CITY PLANNING COMMISSION

APPLICANT	Comstock Johnson Architects, 10304 Placer Lane, Sacramento, CA 95827		
OWNER	Jackson Properties		
PLANS BY	Comstock Johnson Architects, 10304 Placer Lane, Sacramento, CA 95827		
FILING DATE	6/9/89	ENVIR. DET.	Neg. Dec. w/o MM
ASSESSOR'S PCL. NO.	010-0254-016 / 010-0255, 01, 02, 03		REPORT BY CS:kjr

The applicant is requesting the necessary entitlements to construct a two story, 19,420 sq. ft. office building with on and off-site parking.

EXHIBIT C

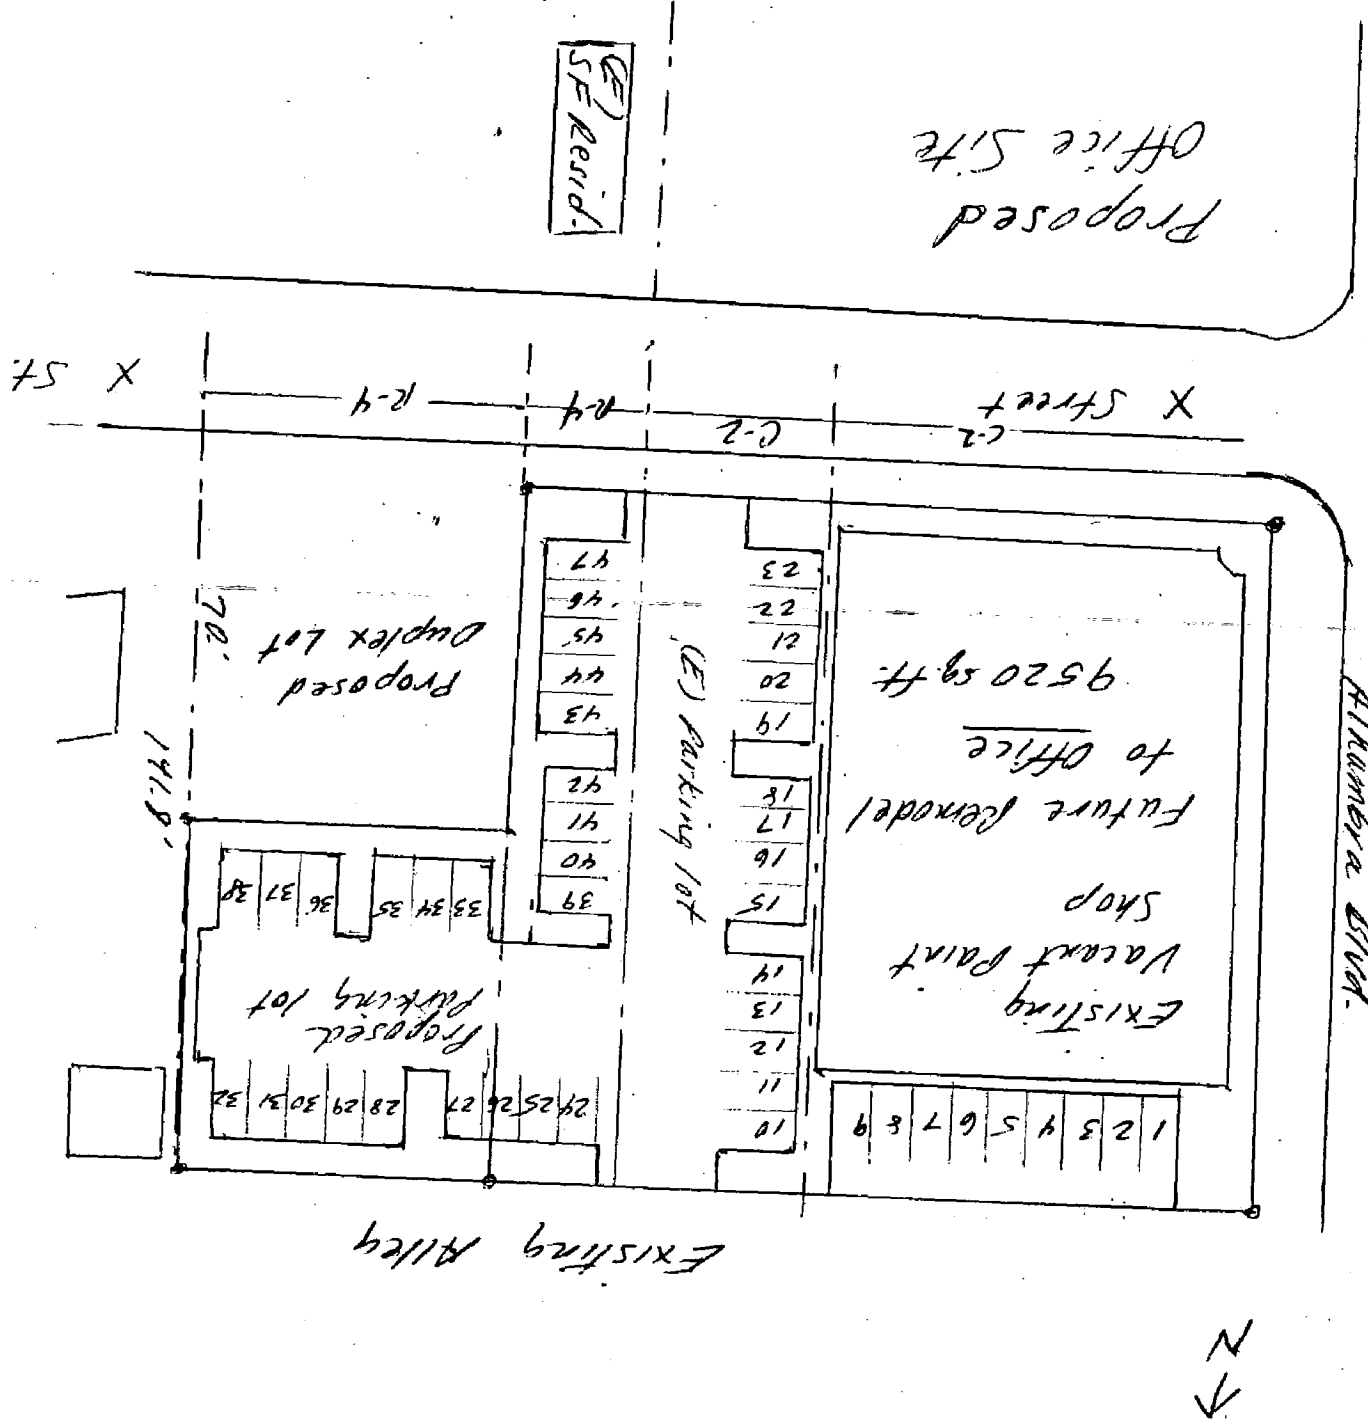
Staff recommends an alternative plan shown in Exhibit C which includes the following:

1. Maintain the R-4 zoning where the off-site parking lot is proposed and request a Special Permit to allow a parking lot in the R-4 zone instead of a rezone to C-2. The purpose for this is to eliminate the possibility of future commercial uses encroaching into a stable single family neighborhood. Also, if the site were rezoned to C-2 the likelihood of a future residential use in this location is significantly reduced. It should be noted that the site could accommodate up to 12 units with the existing R-4 zoning.

2. Redesign the off-site parking lot to include a duplex on the front half of the lot and parking to the rear. Access would be from the adjacent parking lot to the west. Staff recommends that the new parking lot be merged with the existing lot to the west because if the new lot remained separate from the existing westerly lot, a variance to allow access from an adjacent parcel and a subdivision modification to create a landlocked parcel would be required. In order to split the duplex lot from the new parking lot, the applicant would need a parcel map. However, if the new lot is merged with the existing westerly lot, only a lot line adjustment to relocate an existing property line is required. The duplex would maintain the residential block face along X Street.

3. Return to the Commission to request a variance to allow off-site parking partially on the proposed off-site parking lot and partially at the existing parking lot where the vacant paint store is located to the west. Approximately 12 spaces could be provided at the new lot behind the new duplex and approximately 5 to 8 spaces of supplemental parking would be available at the existing lot to the west. The number of spaces depends on if the loading platform is eliminated. Therefore, a minimum of 17 off-site spaces could be made available for the new office building. Staff recommends that the loading dock be removed which will provide 20 of the 26 required off-site stalls.

EXHIBIT E

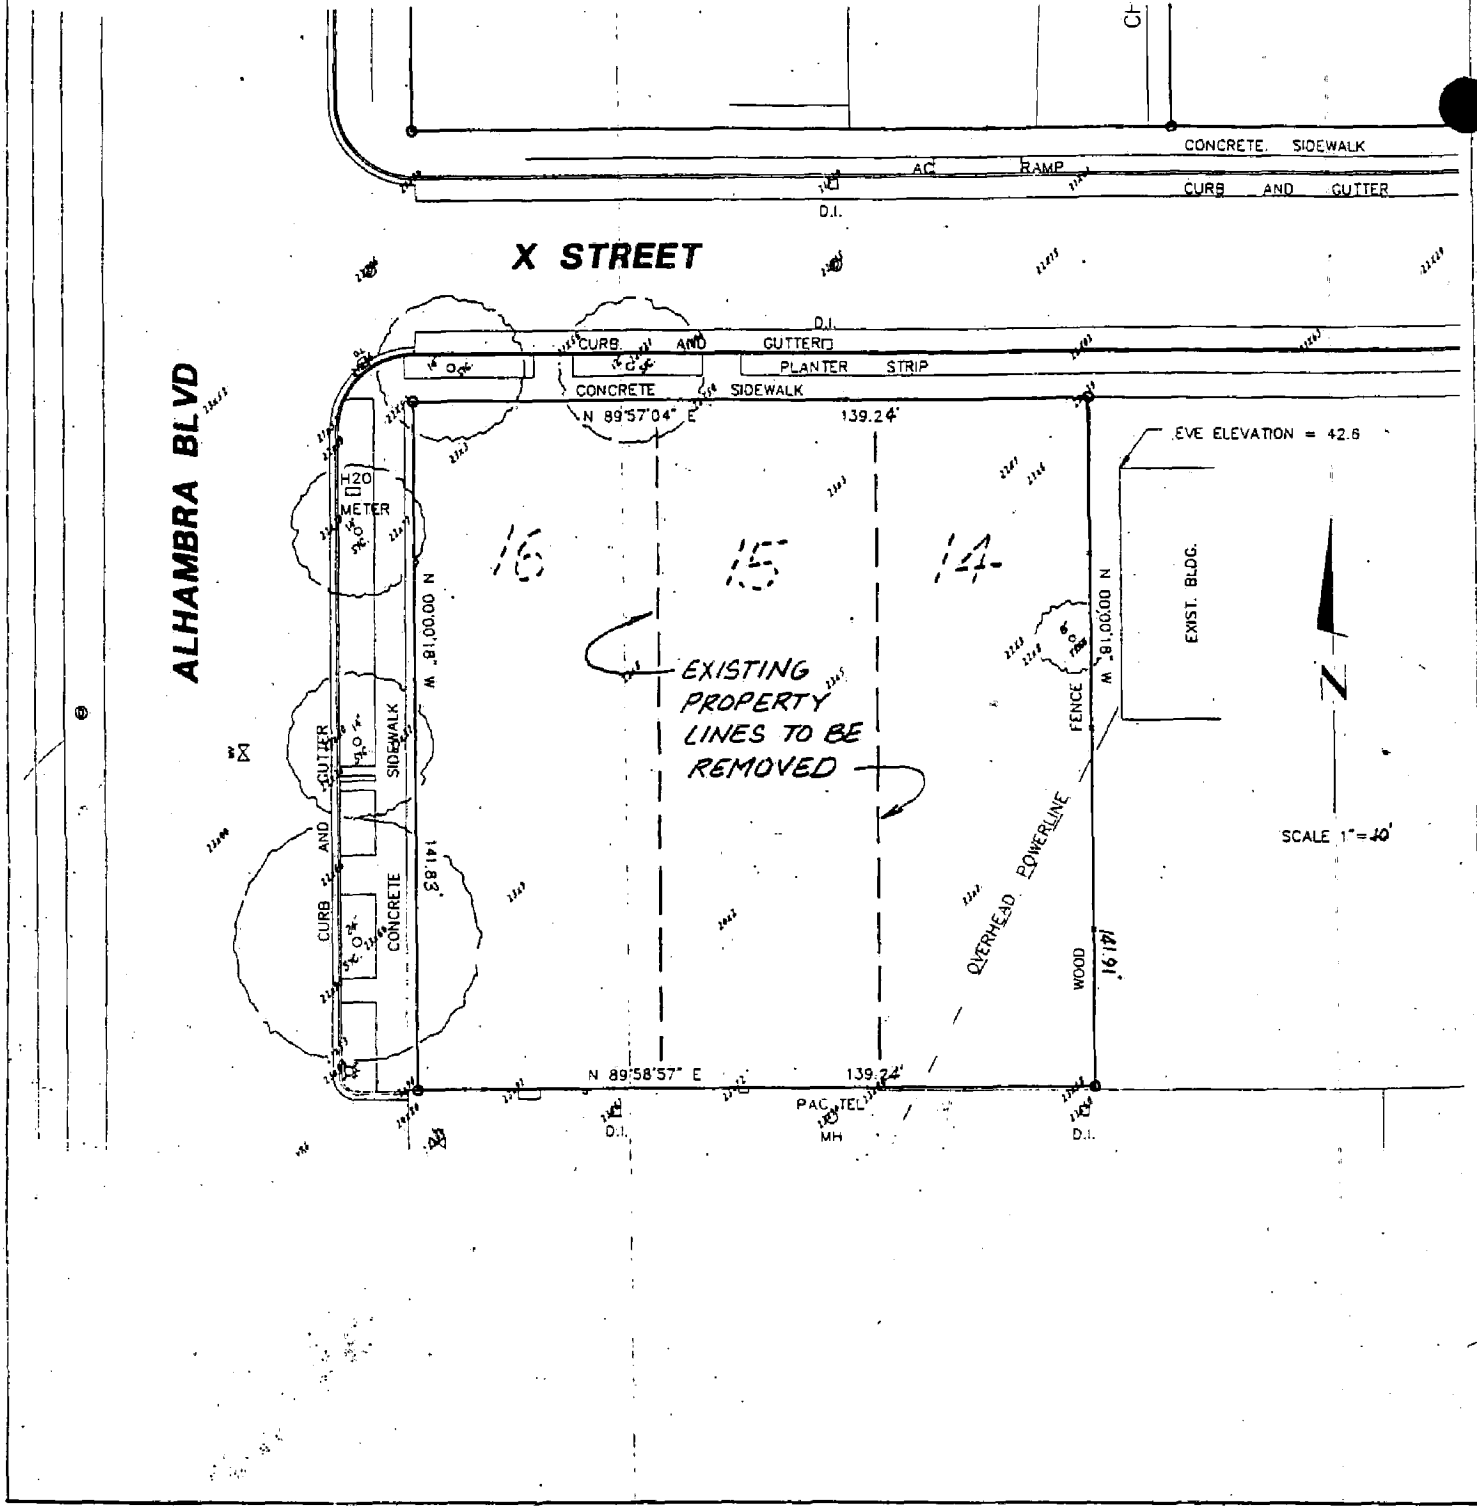
Engineering Division: In reference to the lot line adjustment, pay off or segregate any existing assessments, file a waiver of parcel map, and file a certificate of compliance.
